office memorandum

Date: August 4, 2020
To: Brenda Hall, City Clerk
From: Nathan Madenwald, P.E., Capital Projects Engineer 
Subject: Consent to Encroach 2021-3
(816 Cedarbrook Drive – Block 5, Lot 7, Brookhaven Addition, Section 31)

Consent to Encroachment - 2021-3 - 816 Cedar Brook Drive

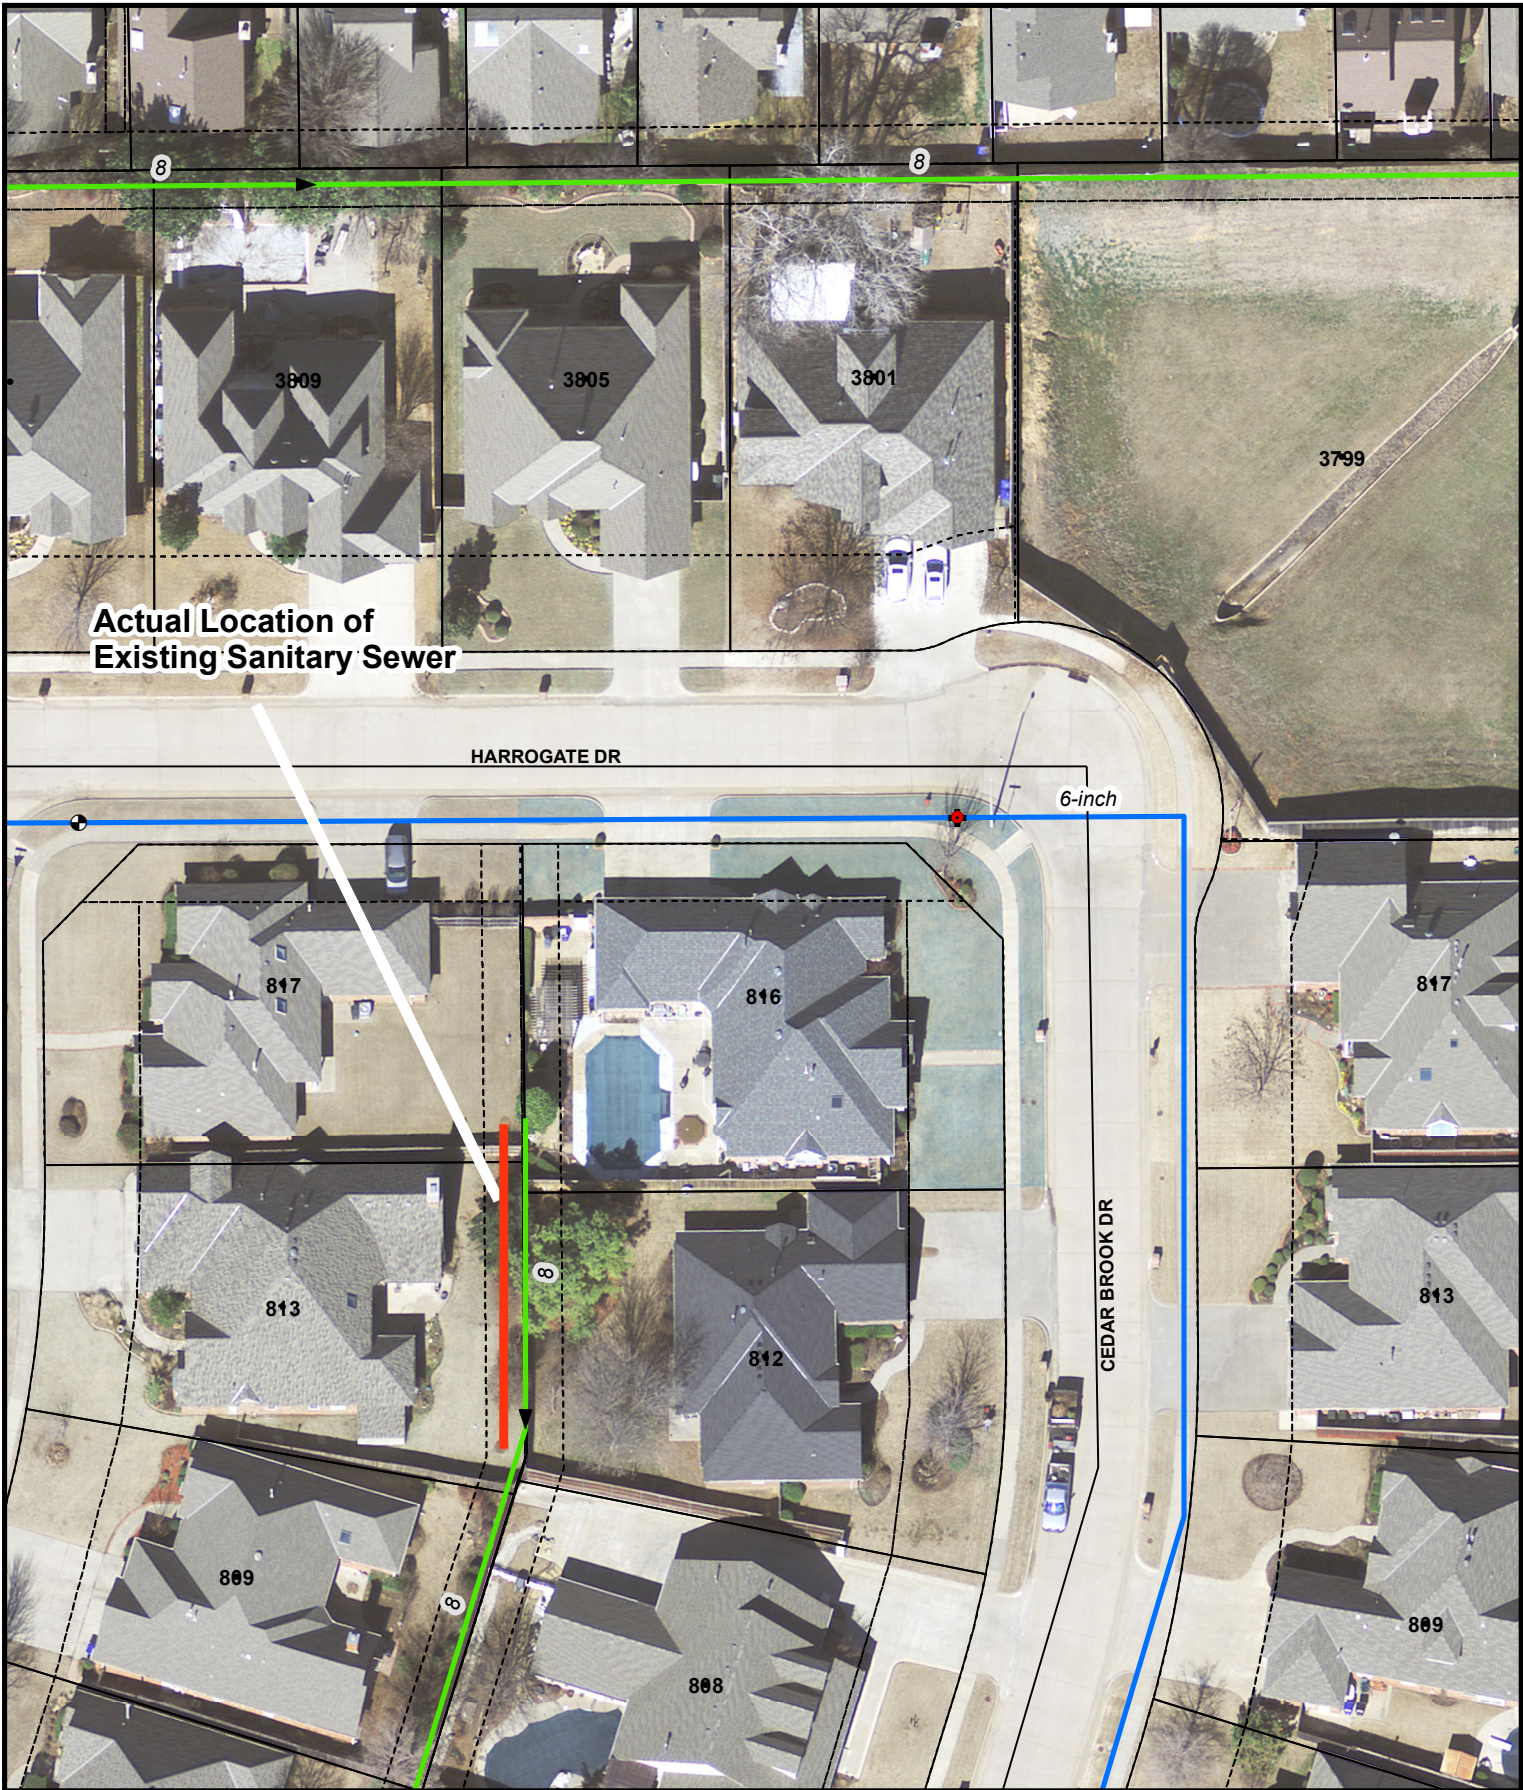
Existing platted utility easements (10 feet in width) lies along the west property line of the subject property and an additional easement (10 feet in width) is platted for the abutting property owner to the west for a total easement of 20 feet. The applicant proposes to encroach into said easement to install a retaining wall to improve drainage. An existing pergola is also partially located in the easement.

No water or sanitary sewer facilities are located within the easement for the above property. An existing 8-inch PVC sanitary sewer line is located within the easement for the abutting property owner at an average depth of 7 feet. The existing water lines are located out in the right-of-way for Harrogate Drive and Cedarbrook Drive.

The Utilities Authority objects to all encroachments on utility easements. However, if the applicant agrees to the following requirements with consent document filed of record on the property for the duration that the private improvements and the encroachment are in place, NUA staff will not oppose a recommendation for approval:

1. The property owner will be responsible for the cost to repair any damages to the City's utilities caused by any excavation, piercing or other construction activities conducted by the property owner or his agents.
2. The property owner will be responsible for the cost the City incurs to remove any fence, curb, landscaping, retaining wall, pergola, and/or any other structure if needed to maintain or repair NUA facilities.
3. The property owner will be responsible for the cost to repair or replace any fence, curb, landscaping, retaining wall, pergola, or any other structure after such repairs.
4. The property owner will waive and release any claims against the City for any damages to the residence and related improvements caused by failure or repair and maintenance of the City's utilities within the easement area.
